PLANNING AND DEVELOPMENT SERVICES STAFF REPORT

For the Planning Commission Meeting of May 5, 2020

**SUBJECT: MMG Plymouth Road Mixed Use Development
(3611-3621 Plymouth Road)
Rezoning – Project no. Z19-007
Site Plan for City Council Approval with Planned Project
Modifications – Project No. SP19-003
Special Exception Use – Project No. SEU19-002**

PLANNING AND DEVELOPMENT SERVICES REVISED STAFF REPORT

Figure 1 – Comparison of Site Plan #4 (Previous) and Site Plan #7 (Proposed) Dimensional Layout Sheets:

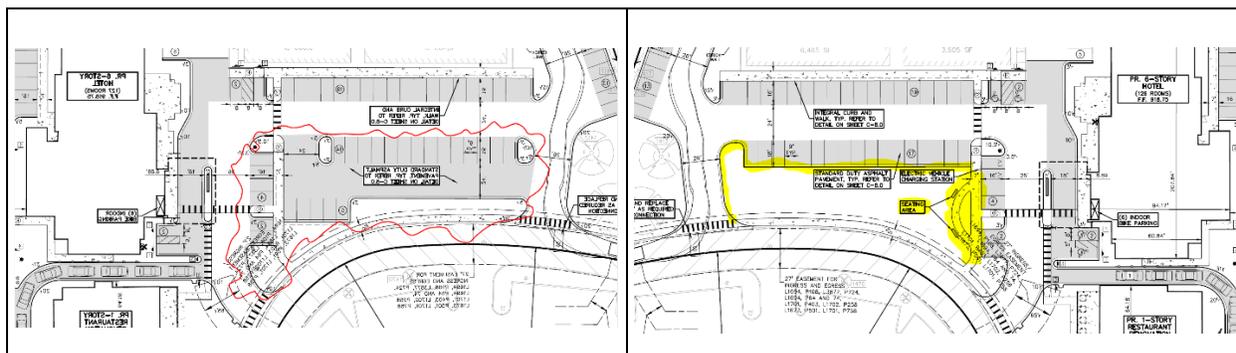
Site Plan – A portion of the parking area south of the existing, remaining hotel and west of the proposed hotel, north of the street, has been replaced with lawn and a seating area. See Figure 1.

ORIGINAL ISSUE DATE:
 JANUARY 30, 2018
 PEA JOB NO. 2017-435
 SCALE: 1" = 50'
 DRAWING NUMBER:
C-1.1

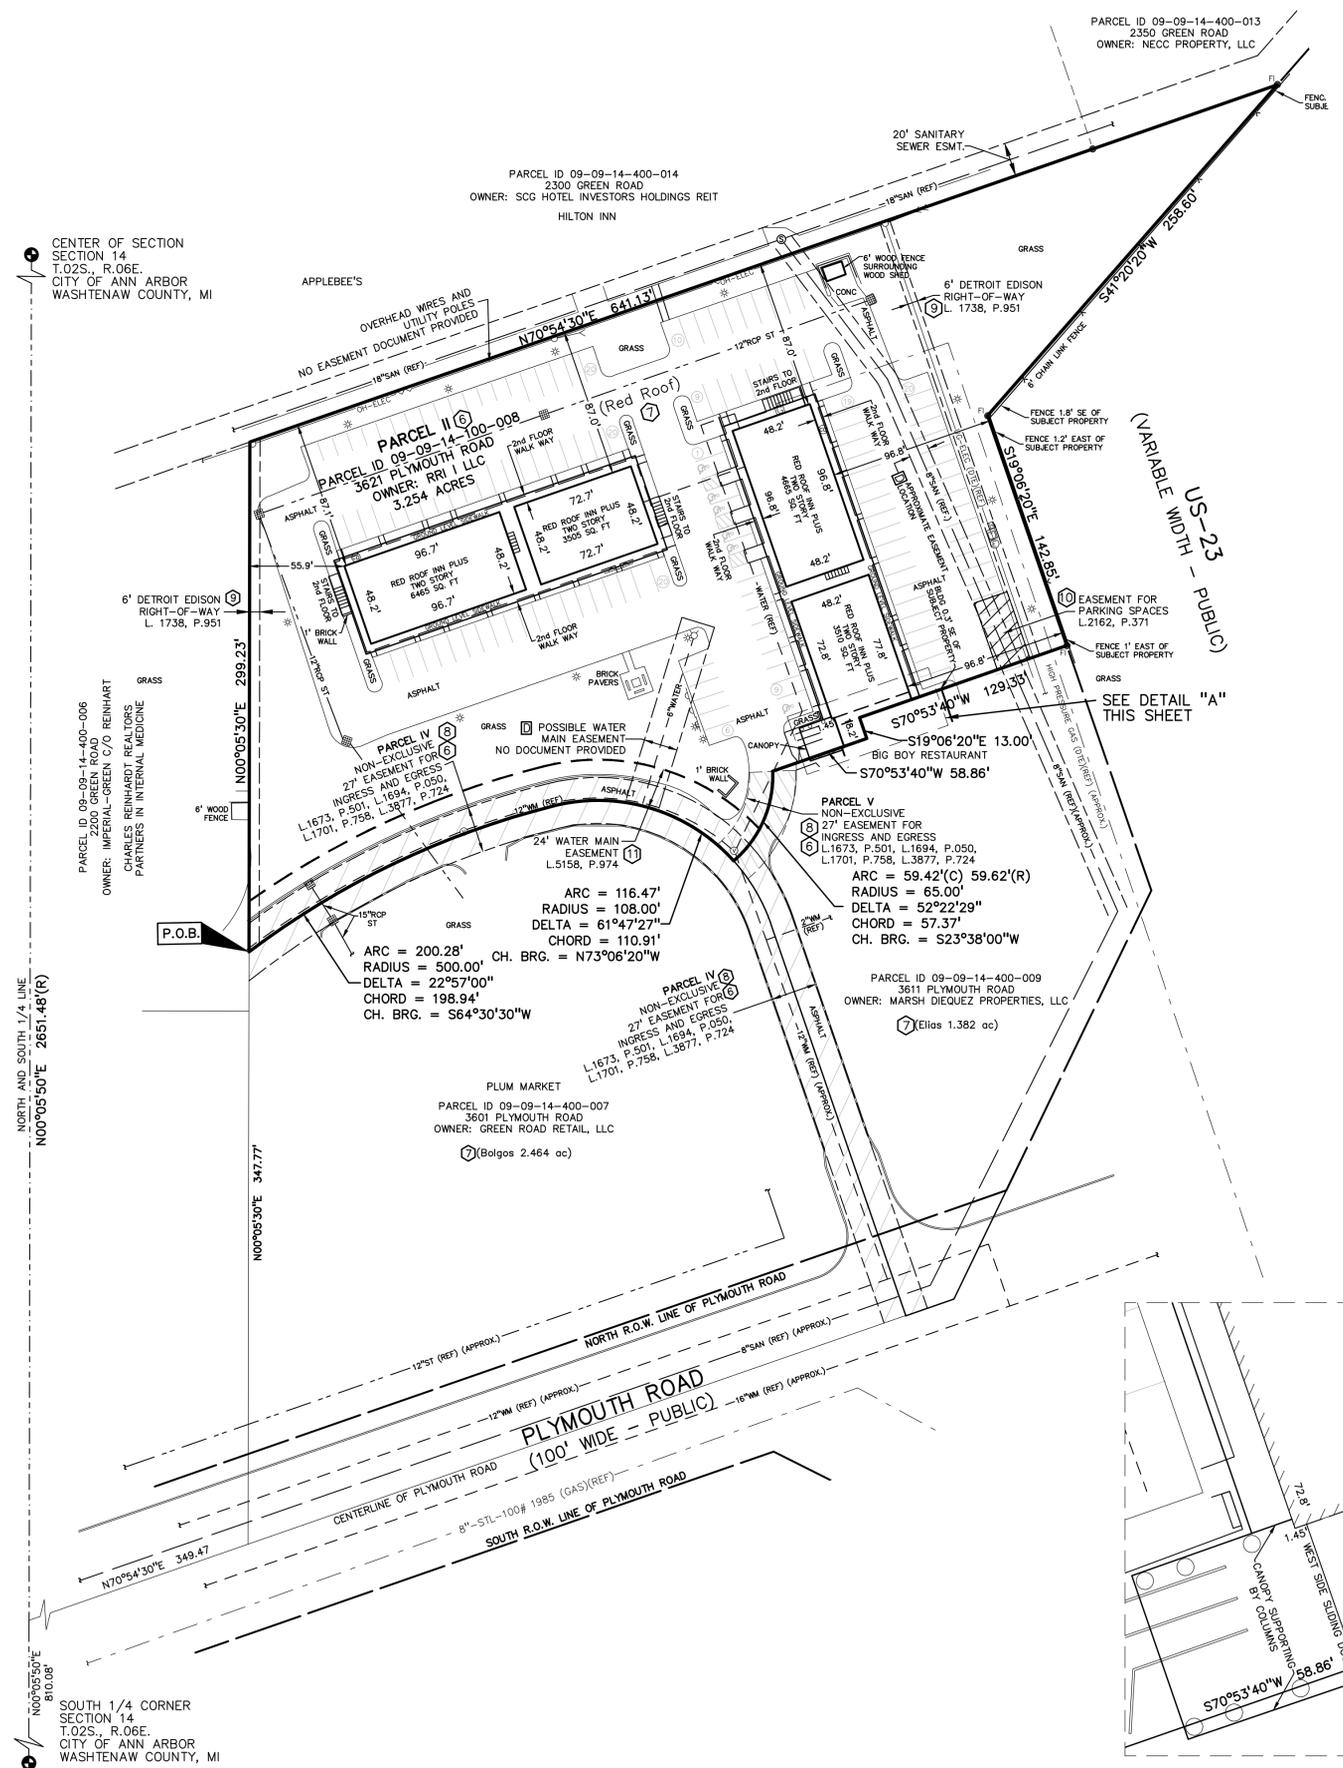
1. Sheet C-1.0 and C-1.1: All easements shall reference the recorded Liber and Page numbers.
2. Sheet C-2.0 - Dimensional & Paving Plan:
 - a. An easement for the western portion of the proposed sidewalk along Plymouth Road shall be shown on the plans.

DRAWING NUMBER:
C-2.0

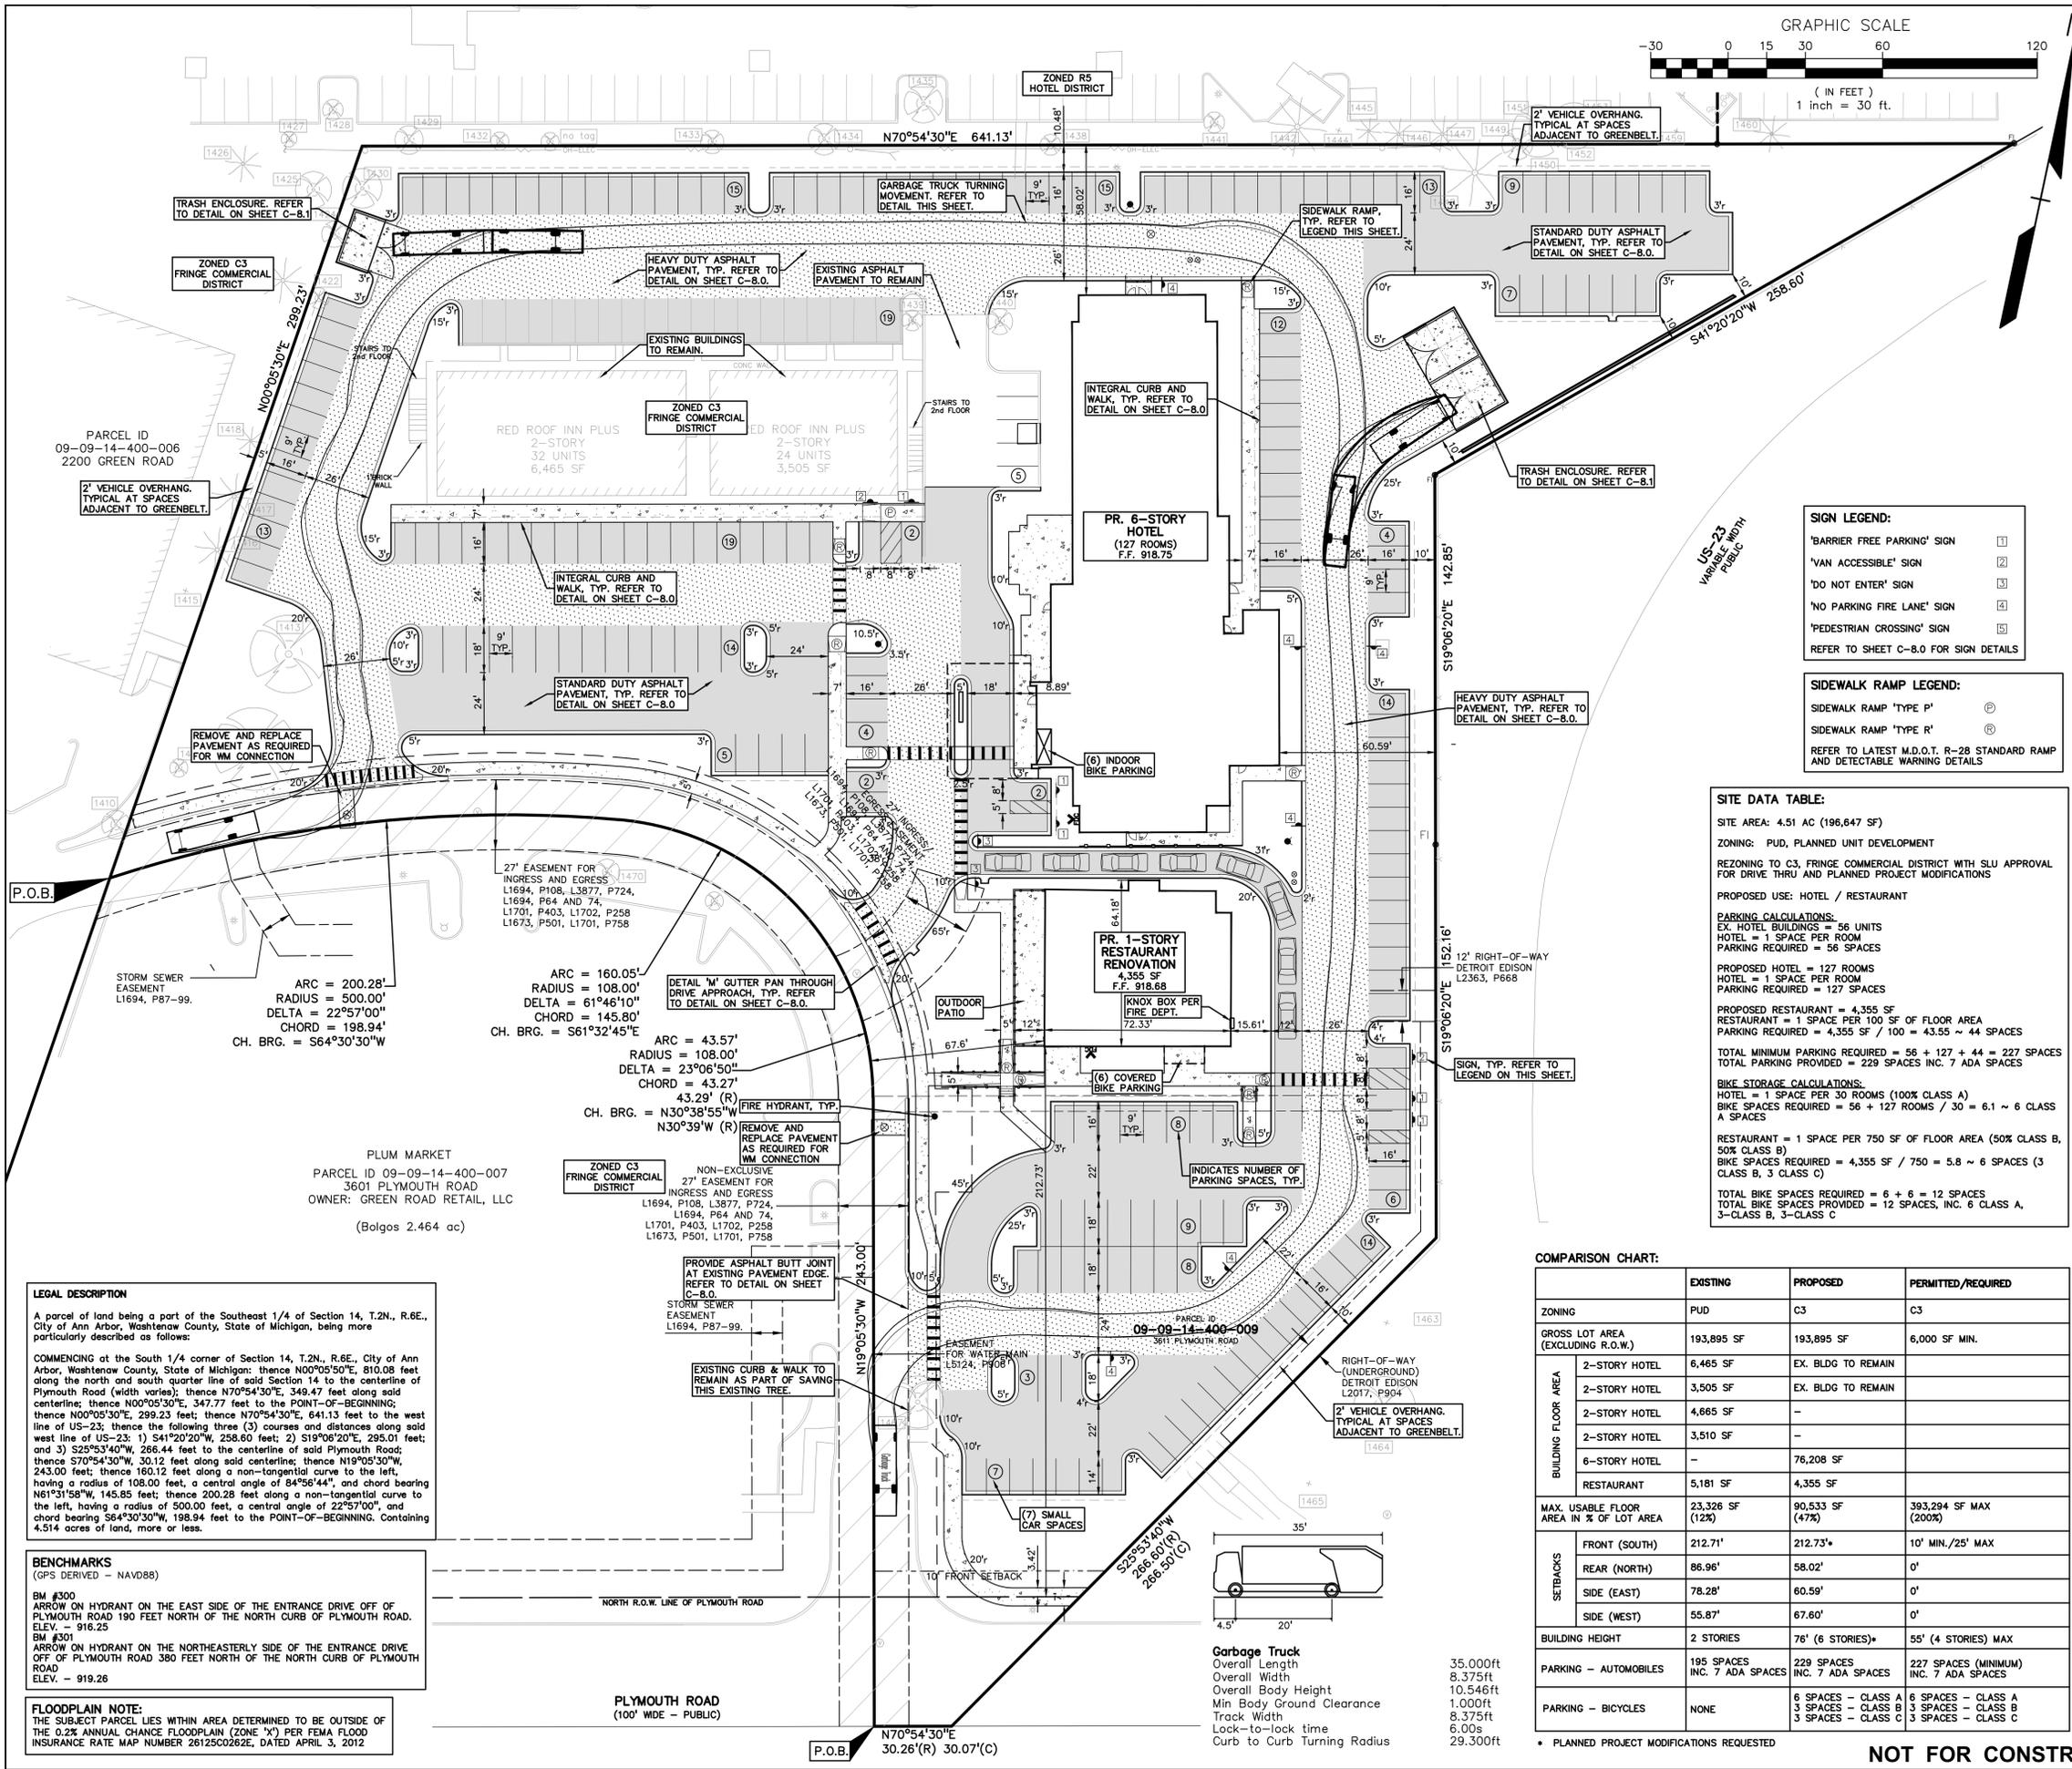
- c. The sidewalk note shall reference Chapter 49, not "R9."
3. Sheet C-5.0 - Utility Sheet:
 - a. Show the location and size of water and sanitary sewer leads that serve the two existing 2-story hotel buildings that will remain on the western half of the parcel.

ORIGINAL ISSUE DATE:
JANUARY 31, 2019
PEA JOB NO. 2017-435
SCALE: 1" = 30'
DRAWING NUMBER:
L-1.0

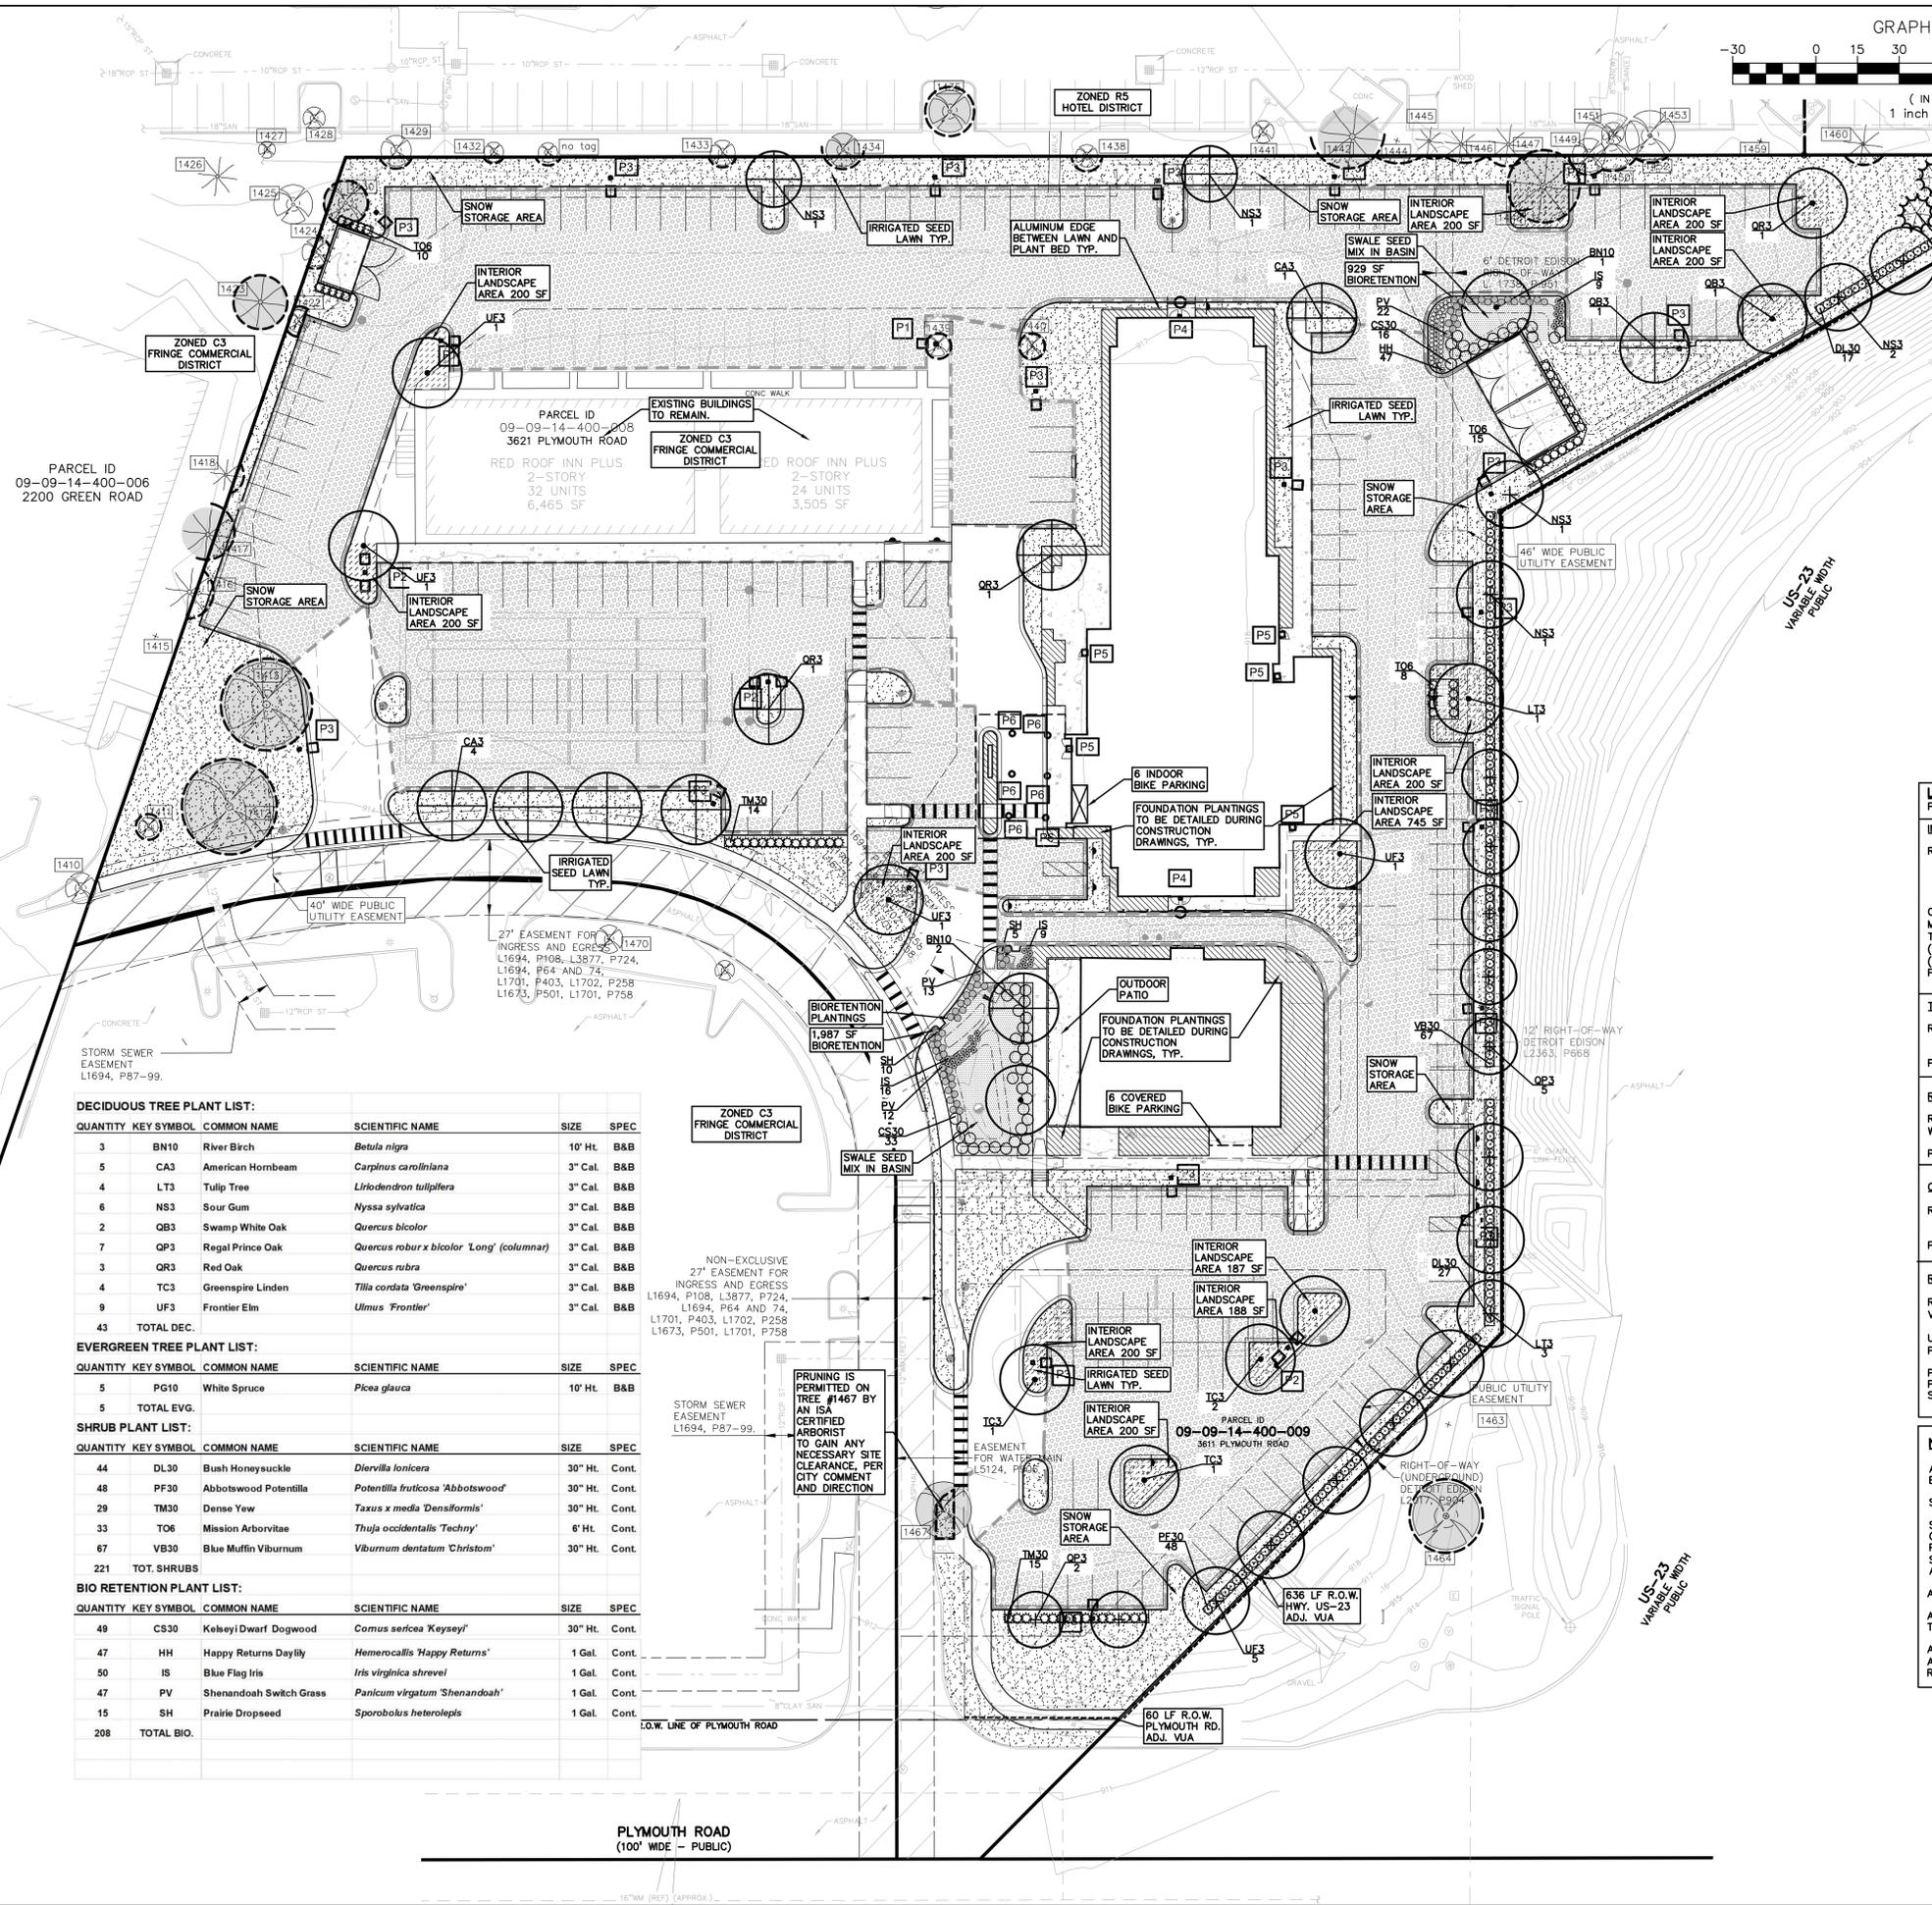
1. **Sheet L-1.0. Deciduous Tree Plant List. Mitigation Trees.** Landmark mitigation trees must be native to Michigan, and must be straight speices, not cultivars or varieties. The following speices are not native to Michigan and/or are cultivated variety that has a form that is not found naturally in Michigan.
 - a. Betula nigra (River birch): not native to Michigan.
2. **Sheet L-1.1. General Planting Notes.** (Chapter 55, Article V 5.29.6.) The following notes must be added to the Notes section.
 - a. Change Note 17 from Chapter 62 stds.” to “city code”. Chapter 62 no longer exists.
